**Re: Status Letter for a Draft Plan of Subdivision
355 Franktown Road
Part of Lot 15, Concession 11, Geographic Township of Beckwith,
now Town of Carleton Place, County of Lanark
County of Lanark File No. 09-T-23001**

Re: Draft III Comments – 355 Franktown Road (File - 09-T-23001)
Proponent – 11309455 Canada Corporation

To:	Diane Reid, Environmental Planner
From:	Jane Cho, Water Resources Engineering Intern
RE:	SWM Engineering Review of the Draft Plan of Subdivision for 347 Franktown Road, Town of Carleton Place
MVCA File No.:	PCPSB-19
Munic. Ref. ID.:	09-T-22002
Date:	May 3, 2024

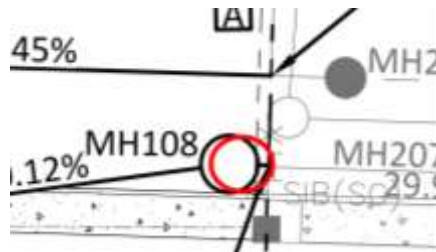
- The servicing report will need to include language on how the site adheres to the water balancing requirements outlined in the Town's C.L.I. E.C.A. The appropriate forms will need to be completed and submitted to the Town.
- Plan and profile drawings were not included that were submitted in submission #2.
- The proponent will need to demonstrate how the oil grit separator is adhering to the testing protocol in Section 5.2.4 of the C.L.I. E.C.A. which must follow the Environmental Technology Verification (ETV) protocol. Please ensure that during the detail design and within the storm water management report they indicate how the oil grit separator will be following this regulation.
- Details on the oil grit separator will need to be provided or a brochure on the unit that is being utilized.
- Storm manhole 108 should be connecting directly to the existing stub as shown below.
